**DEPARTMENT OF TRANSPORTATION
STATE OF GEORGIA
REVISED PROJECT CONCEPT REPORT**

Project Number: NHS00-0001-00(570)

REVISED PROJECT CONCEPT REPORT

Description of the approved concept: At various locations on this corridor the existing median crossover will be reconstructed to provide Type “B” Median Crossovers – Offset left turn lanes for SR 3. The existing Type “A” Median Crossovers – Adjacent Left Turn Lanes will be reconstructed as Type “B” Median Crossovers. Right turn lanes will also be constructed and/or extended to meet speed design deceleration distances at various locations. Right turn lanes will only be constructed if they can be done within the existing right of way. The locations as shown in the approved concept are:

EXISTING TYPE 'A' X-OVER
PROPOSED TYPE 'B' X-OVER W/RIGHT TURN LANE

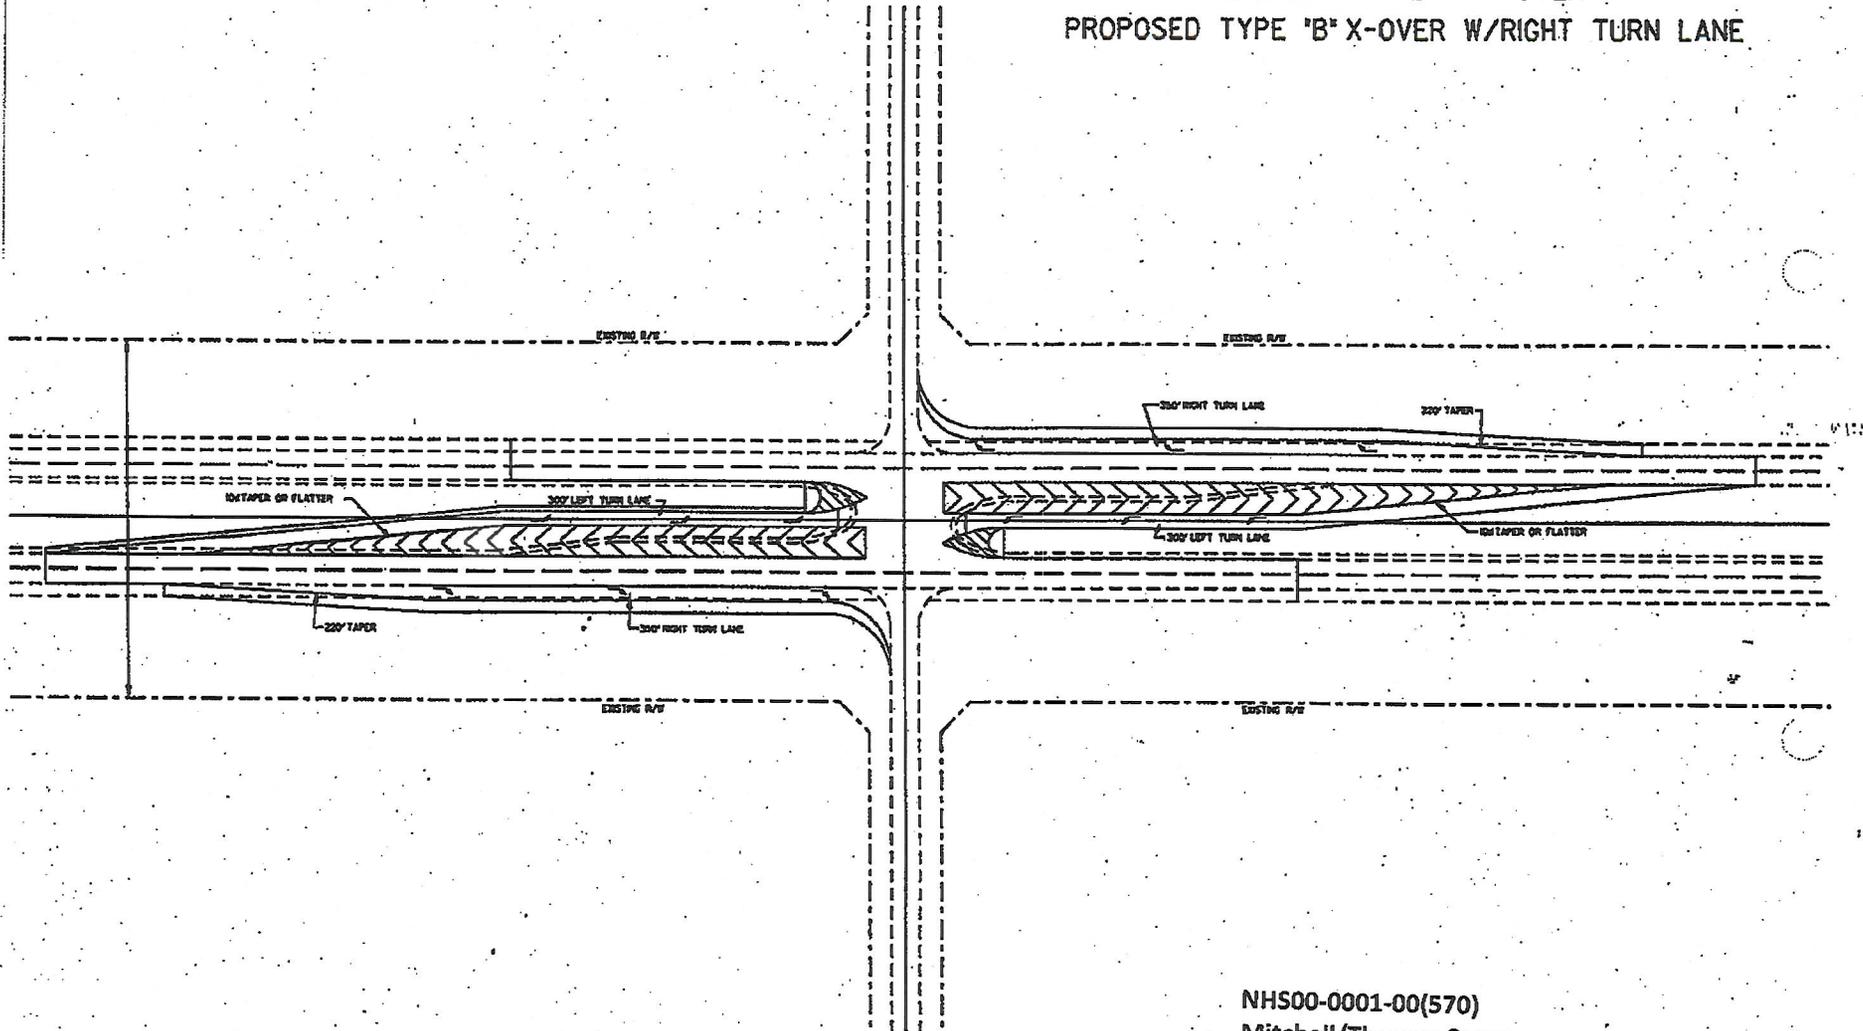
<p>Approved Features: The approved project features are to reconstruct the existing Type “A” median crossovers on SR 3/SR 300/US 19 to provide Type “B” Median Crossovers. Right turn lanes will be constructed and/or extended to meet speed design deceleration distances only if they can be constructed within the existing right of way.</p>	<p>Proposed Features:</p> <ul style="list-style-type: none"> • Closures of median crossovers CR 127/Marshall Street in Thomas County and MP 0.00 in Mitchell County. • Add MP 0.00 median crossover in Mitchell County to the list of project locations. • Remove CR 246/Old Monticello Road and SR 202/CR 247/County Line Road intersections. Remove MP12.59/Constitution Avenue median crossover in Thomas County.
<p>Reasons for Changes: The SR 300/US19 median crossover at CR 127/Marshall Street and the SR 3/SR 300/US19 median crossover at Mitchell County MP 0.00 in proximity to SR 3/SR 111 in Thomas County do not meet GDOT Design Policy Manual median opening spacing requirements and should be closed. CR 127/Marshall Street and MP 0.00 have significantly lower traffic volumes than SR 3/SR 111, and SR 3/SR 111 should remain open. MP 0.00 median crossover in Mitchell County should be added to the list of project locations since its proposed closure is located within the project termini. The CR 246/Old Monticello Road intersection is a circulatory intersection and not an existing Type “A” Median Crossover. Crash, injury and fatality rates at this intersection are below the statewide average for the years of 2006-2008, so the intersection should be removed from the concept. The SR 202/CR 247/County Line Road intersection has been improved by intersection improvement project CSSTP-0007-00(075) and should be removed from the concept. MP12.59/Constitution Avenue median crossover is an existing Type “B” median crossover and should be removed from the concept.</p>
